DATE OF DETERMINATION	23 August 2025
DATE OF PANEL DECISION	22 August 2025
DATE OF PANEL BRIEFING	14 August 2025
PANEL MEMBERS	Abigail Goldberg (Chair), David Ryan, Steve Murray, Clr. Sameer Pandey
APOLOGIES	Clr. Michael Ng
DECLARATIONS OF INTEREST	None

PPSSCC-521 – City of Parramatta – DA/72/2024 – 181 James Ruse Drive, Camellia - demolition, earthworks, site remediation, tree removal and construction of a warehouse and distribution centre. The development is proposed in two phases, the existing hardstand surfaces to be utilised as storage premises in Phase 1 and warehousing and distribution premises will be constructed and operated under Phase 2. The application is Nominated Integrated Development pursuant to Water Management Act 2000 and Integrated Development pursuant to Roads Act 1993.

Figure 1: Stormwater management plan

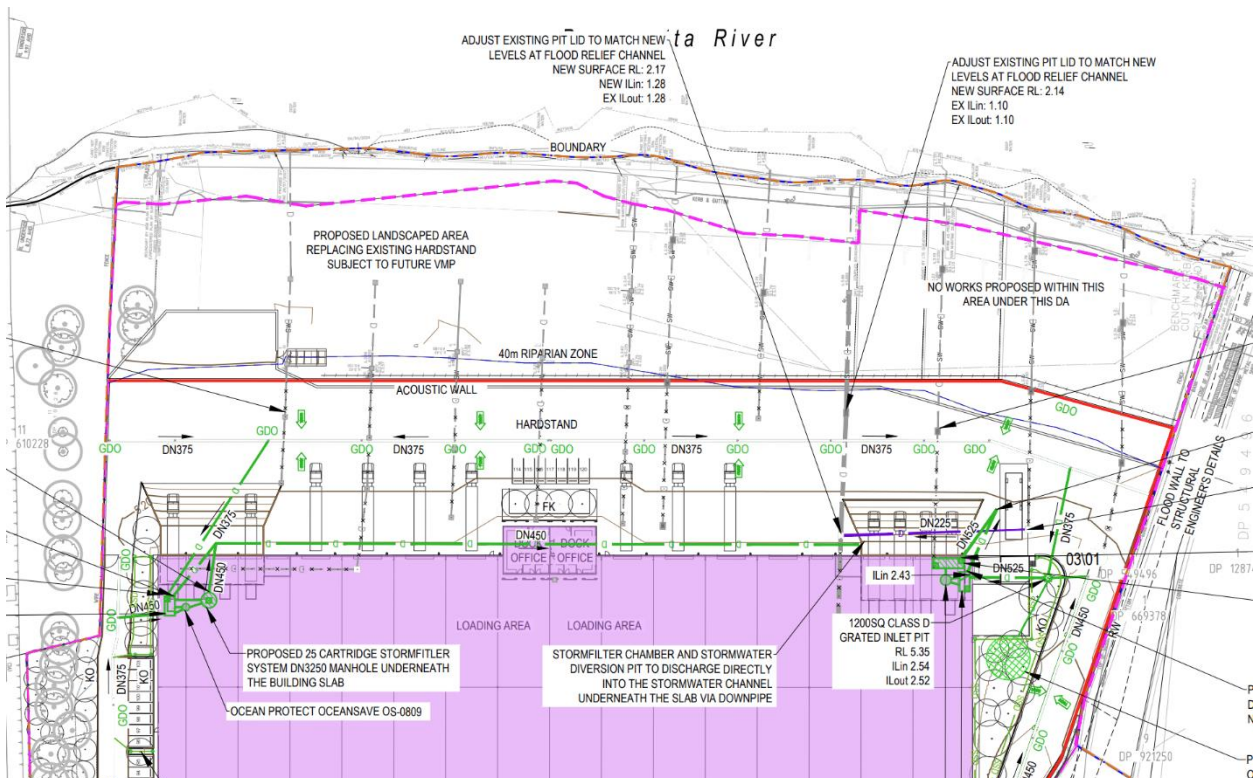
47. It is currently unclear whether all or part of the existing stormwater pipe network (Figure 1) will be retained, and which sections are proposed to be used for discharging stormwater from the site. Therefore, the stormwater drainage plan must be updated prior to the issue of the Construction Certificate (CC) to clearly indicate which existing stormwater pipes are to be retained and used for discharge.

The updated plan must also include key details of the retained infrastructure, including pipe sizes, invert levels, and condition. Additionally, the design must demonstrate the integration of the existing and proposed stormwater networks to ensure they function as a cohesive and complete system.

If stormwater is proposed to be discharged through an existing outlet, the plan must include details of the existing outlet, supported by a condition assessment report. Should the outlet be found to be in poor condition or structurally inadequate, the outlet must be reconstructed to ensure appropriate stormwater discharge.
